SUDAS Revision Submittal Form

Status Date: As of 5/17/2019 **Topic:** Linear trench drain
Manual: Specifications **Manual Location:** Section 4020, 1.08, 2.02, and 3.04
Figure 6010.521

REVISION
		2
FIGURE 6010.521 STANDARD ROAD PLAN		SW-521
DRAFT		SHEET 1 of 2
<i>David D. Wiegand</i> PROJECT ENGINEER		<i>Scott Miller</i> METHODS ENGINEER
LINEAR TRENCH DRAIN

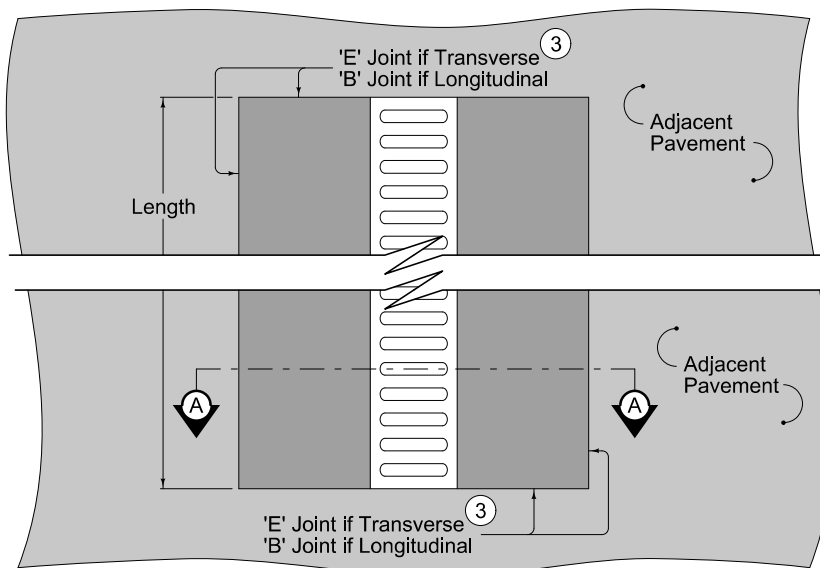
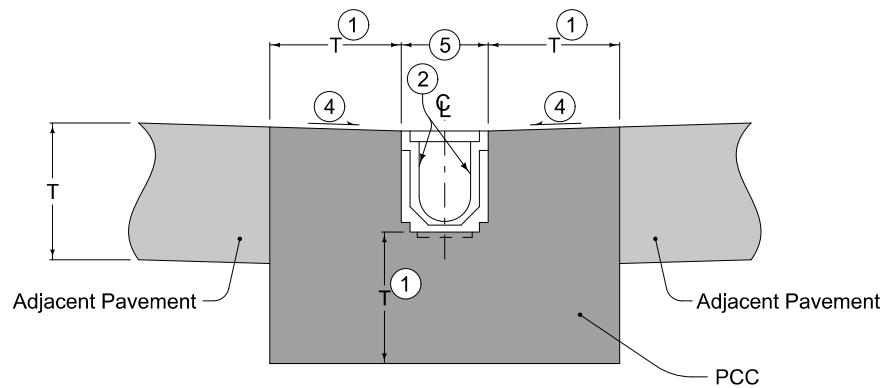
Initial Comments:	Questioned if in 3.04, C, can we just discharge rather than connecting to another structure? <i>Note - done.</i>					
Final Comments:	Questioned the thickness; what would the manufacturer recommend for a minimum thickness? Compare the top T dimension. <i>Note - revised.</i>					
Action:	<input type="checkbox"/> Deferred		<input type="checkbox"/> Not Approved		<input checked="" type="checkbox"/> Approved	
District:	<input type="checkbox"/> 1	<input type="checkbox"/> 2	<input type="checkbox"/> 3	<input type="checkbox"/> 4	<input checked="" type="checkbox"/> 5	<input type="checkbox"/> 6
Initial Comments:	Make sure the possible contract item and possible tabulation language isn't included on the figure. <i>Note - done.</i> They also questioned if there is reinforcing like in boxouts. <i>Note - no.</i>					
Final Comments:	Questioned the thickness; what would the manufacturer recommend for a minimum thickness? Compare the top T dimension. <i>Note - revised.</i>

- ① 6 inches or same as thickness of adjacent pavement, whichever is greater.
- ② Linear Trench Drain.
- ③ For joint details, see PV-101.
- ④ Slope same as adjacent pavement.
- ⑤ Width as determined by manufacturer. Minimum 6 inches.
